**MISSISSIPPI RIVER & TRIBUTARIES-
MORGANZA, LOUISIANA TO THE GULF OF MEXICO
HURRICANE PROTECTION:**

**Houma Navigation Canal (HNC) Lock Complex
and Associated Structures**

**ENVIRONMENTAL IMPACT STATEMENT
SCOPING DOCUMENT**

May 12, 2006

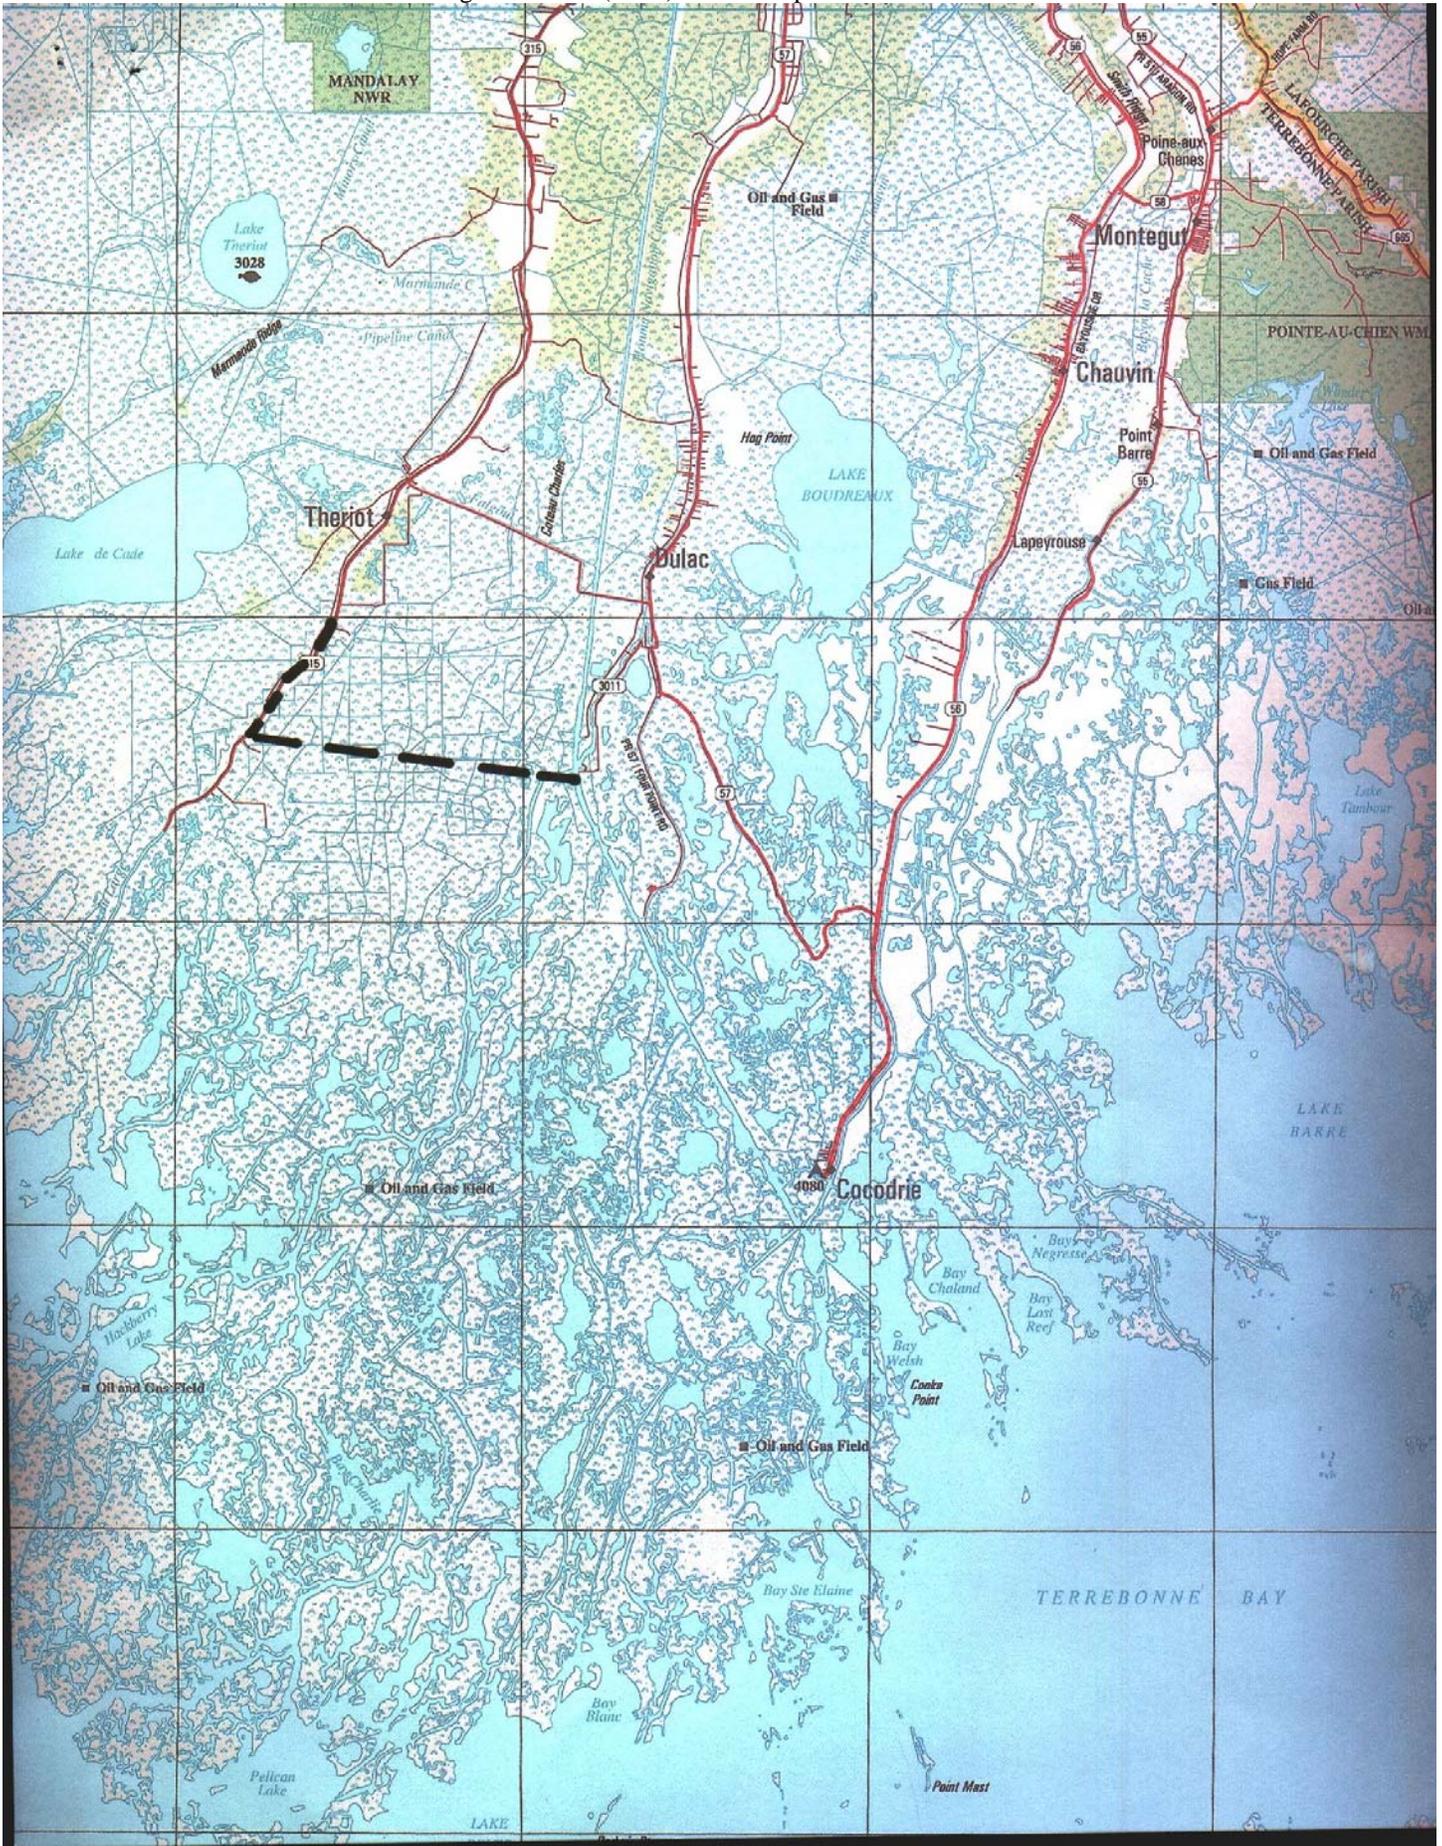
I have enclosed a map showing the route of the levee as proposed by the Harry Bourg Corporation. If you have any questions about this proposal, please contact me at the above address.
